SUNDRY NOTICES AND REPORTS ON WELLS (DO NOT USE THIS FORM FOR PROPOSALS TO DRILL OR TO DEEPEN OR PLUG BACK TO A DIFFERENT RESERVOIR. USE "APPLICATION FOR PERMIT" (FORM C-101) FOR SUCH PROPOSALS.)		WELL API NO. 30-045-38315

2. Name of Operator SIMCOE LLC		6. State Oil & Gas Lease No. NMNM03358
3. Address of Operator 1199 MAIN AVE., STE #101, DURANGO, CO 81301		7. Lease Name or Unit Agreement Name NORTHEAST BLANCO UNIT

4. Well Location Unit Letter <u>D</u> : <u>690</u> feet from the <u>NORTH</u> line and <u>804</u> feet from the <u>WEST</u> line Section <u>12</u> Township <u>31N</u> Range <u>7W</u> NMPM County <u>SAN JUAN</u>		8. Well Number <u>006H</u>

SIMCOE LLC is requesting to extend the Surface Casing to 3,601' TVD.

Wellbore Schematic

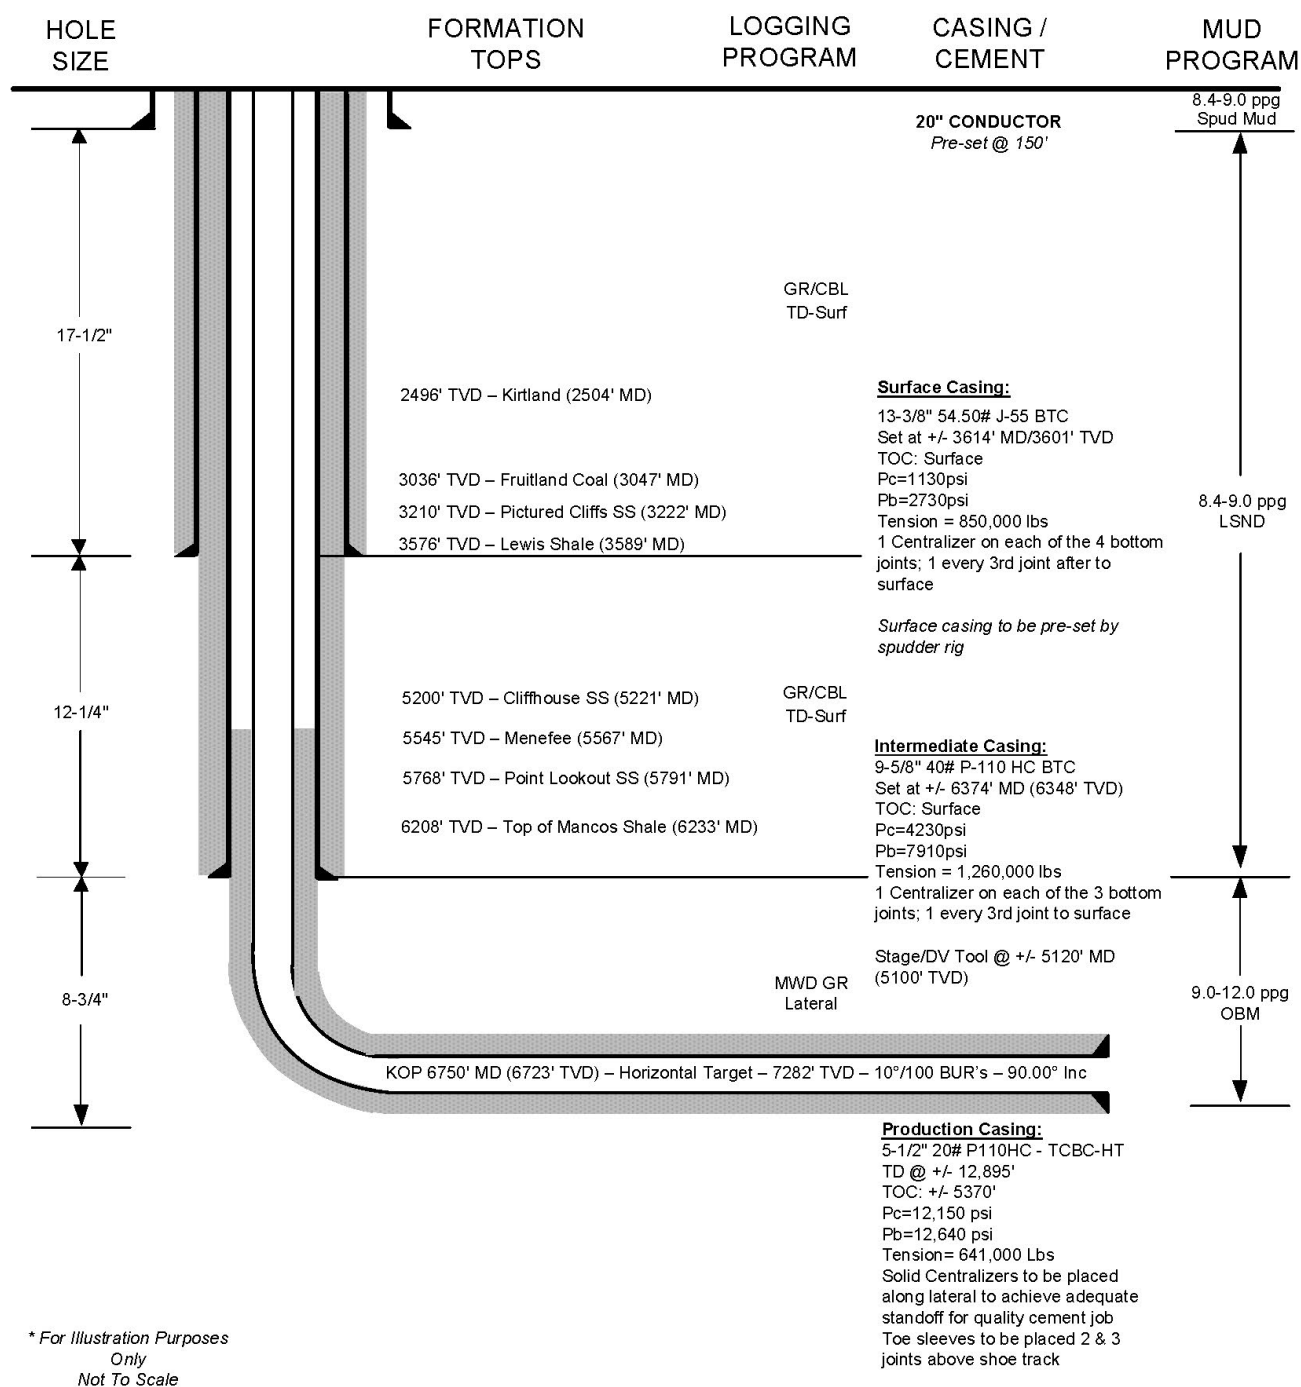
Current Surface Casing Program (as approved in the APD):

Casing size 13-3/8" set at ±1100' TVD; conventional cement job (1 stage), circulated to surface.

Revised Surface Casing Program:

Casing size 13-3/8" set at ±3601' TVD (roughly 25' into the Lewis Shale); conventional cement job (1 stage), circulated to surface.

To mitigate expected lost circulation problems in previously designed long (±5500' MD), deviated intermediate casing section; extreme lost circulation encountered both in offset operator's wells in addition to historic BP NEBU wells; will allow depleted intervals in Kirtland, Fruitland Coal, & Pictured Cliffs to be isolated behind pipe (surface casing) before drilling into the known depleted intervals in the Mesa Verde section; setting surface casing deeper (into the Lewis) allows for improved drilling efficiency & also increases the safety of drilling operations through these depleted sections.

No change to the Conductor, Intermediate and Production casing from the original approved casing program. Please see attached NEBU 602-6H Updated Casing Safety Cement Program for details.

1. Surface casing must be always at a minimum half fluid fill.

Wellbore Schematic

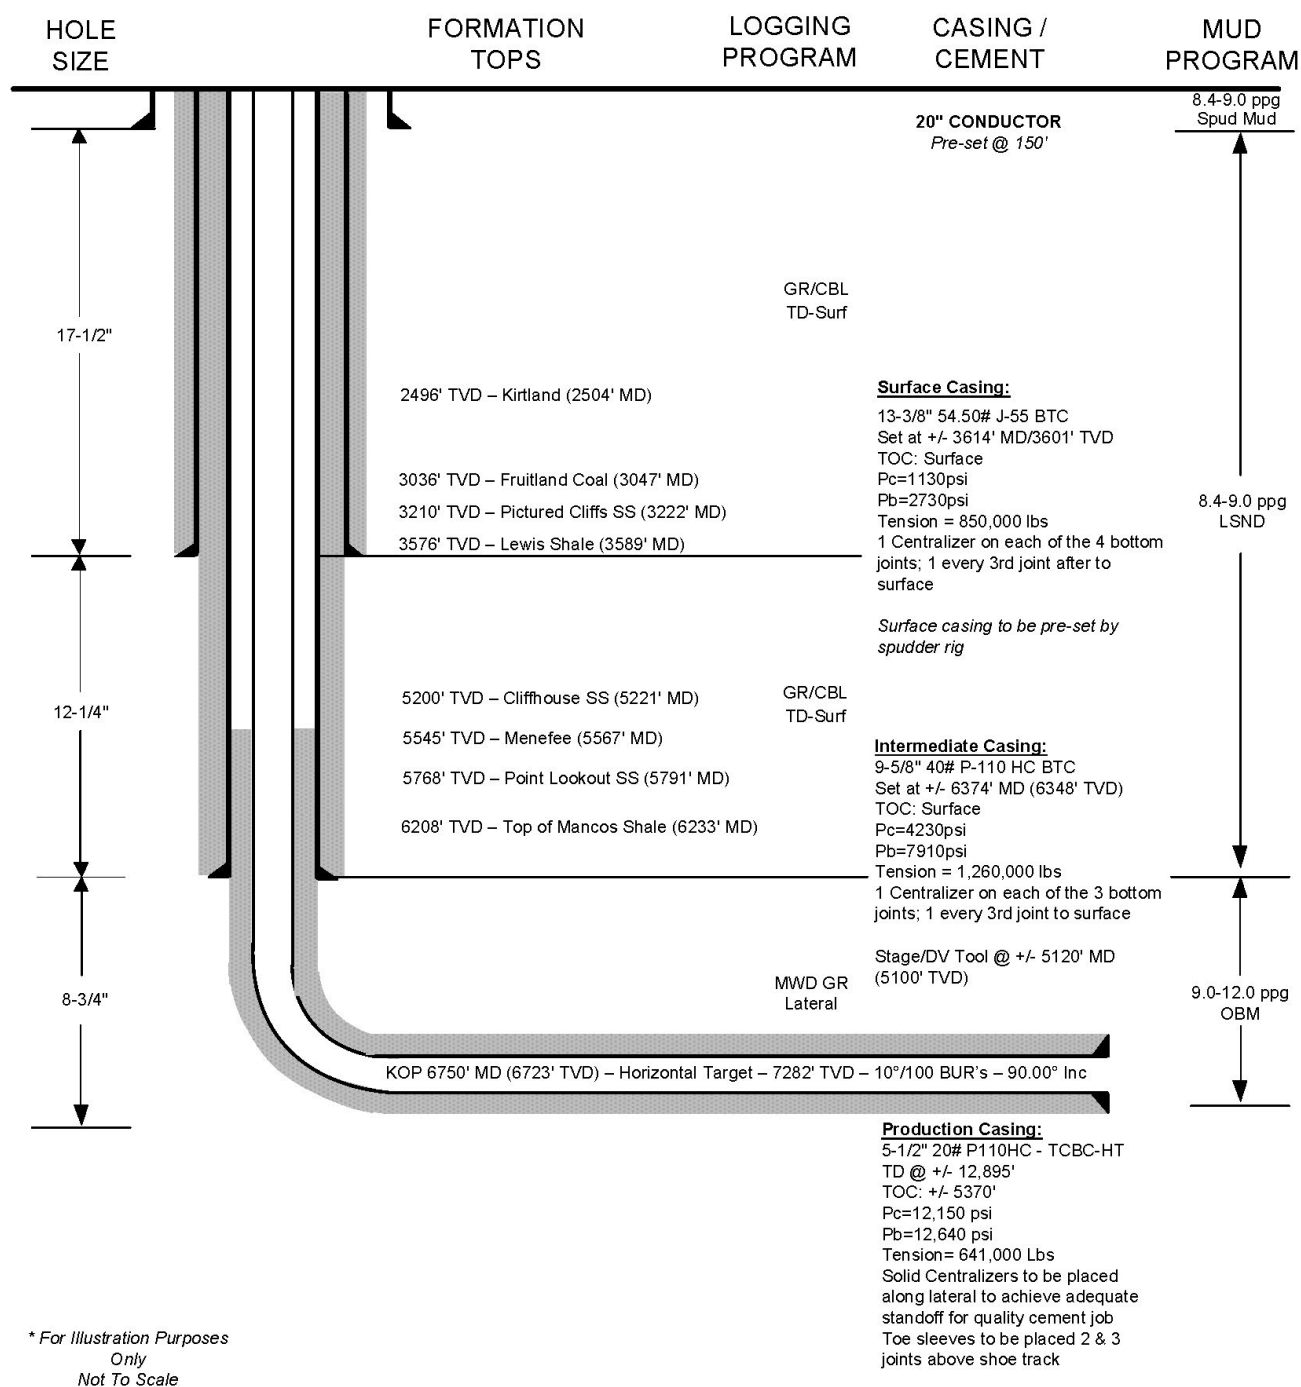
Reasons for setting deeper surface casing.

- to mitigate expected lost circulation problems in previously designed long (5500 MD), deviated intermediate casing section
- extreme lost circulation encountered both in offset operators wells in addition to historic BP NEBU wells
- will allow depleted intervals in Kirtland, Fruitland Coal, & Pictured Cliffs to be isolated behind pipe (surface casing) before drilling into the known depleted intervals in the Mesa Verde section
- setting surface casing deeper (into the Lewis) allows for improved drilling efficiency & also increases the safety of drilling operations through these depleted sections

Please see attached NEBU 602-6H Revised Casing and Cement Program for details.

1. Surface casing must be always at a minimum half fluid fill.
